Re: Application for improvement permit for Richard Hagemeyer
Property Site: lot 5 Kalabash Road
Health Department file no. 4866B

SHEET 1 OF 1	SHEET TITLE: DETAILED SOILS EVALUATION	PROJECT NAME: R.H. HEGEMEYER, INC. - HARBOR VIEW - MECK. COUNTY, NORTH CAROLINA MAY 2002	S&EC Soil & Environmental Consultants, PA

SOIL/SITE EVALUATION
for ON-SITE WASTEWATER SYSTEM

PROPOSED PLOT PLAN

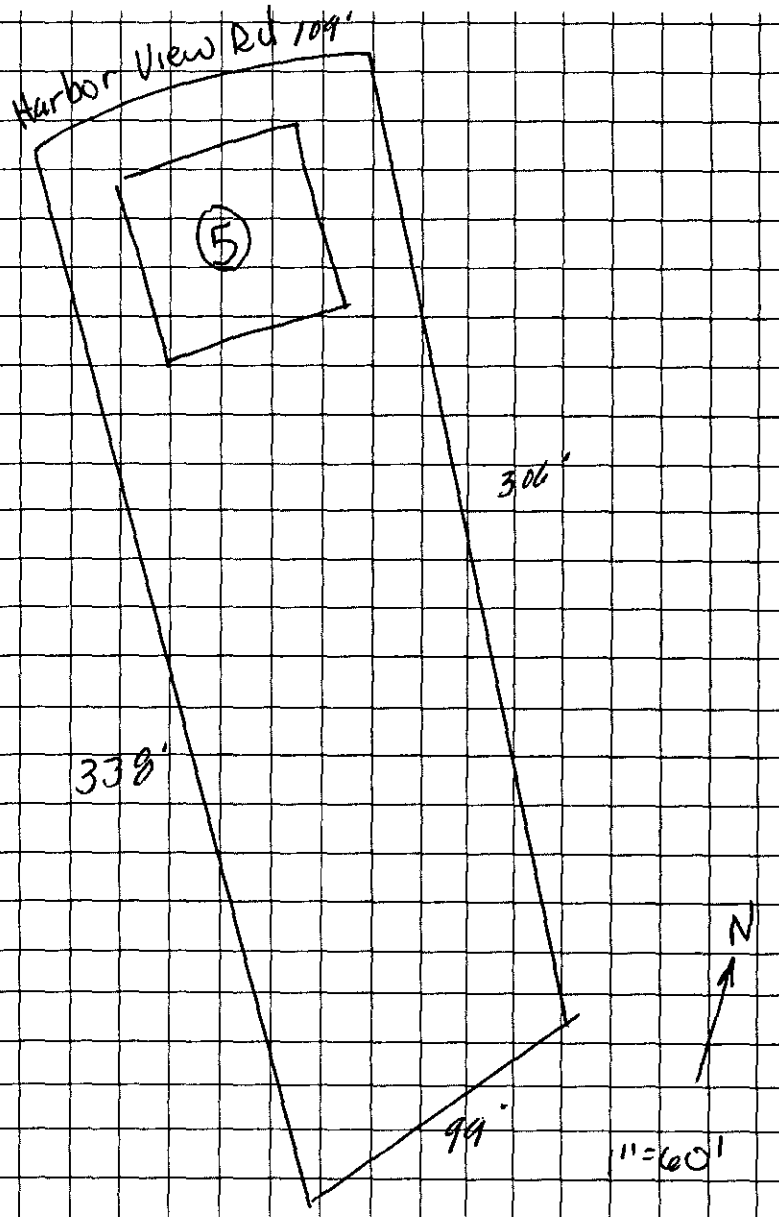
Based on the criteria set out in Title 15A, Subchapter 18A, of the North Carolina Administrative Code, Rules .1940 through .1948, the evaluation indicated that the site is **UNSUITABLE for** a ground absorption sewage system. Therefore, your request for an improvement permit is **DENIED.** A copy of the site evaluation is enclosed. The site is unsuitable based on the following:

___X___Unsuitable soil topography and/or landscape position (Rule .1940)
___X___Unsuitable soil characteristics (structure or clay mineralogy) (Rule .1941)
_____Unsuitable soil wetness condition (Rule .1942)
___X___Unsuitable soil depth (Rule .1943)
_____Presence of restrictive horizon (Rule .1944)
___X___Insufficient space for septic system and repair area (Rule .1945)
_____Unsuitable for meeting required setbacks (Rule .1950)
_____Other (Rule .1946)

Other Factors (.1946): _____
Site Classification (.1948): UNSUITABLE
Evaluated By: W. R. Marlin, LSS, 4/18/02. W. R. Marlin
Others Present:
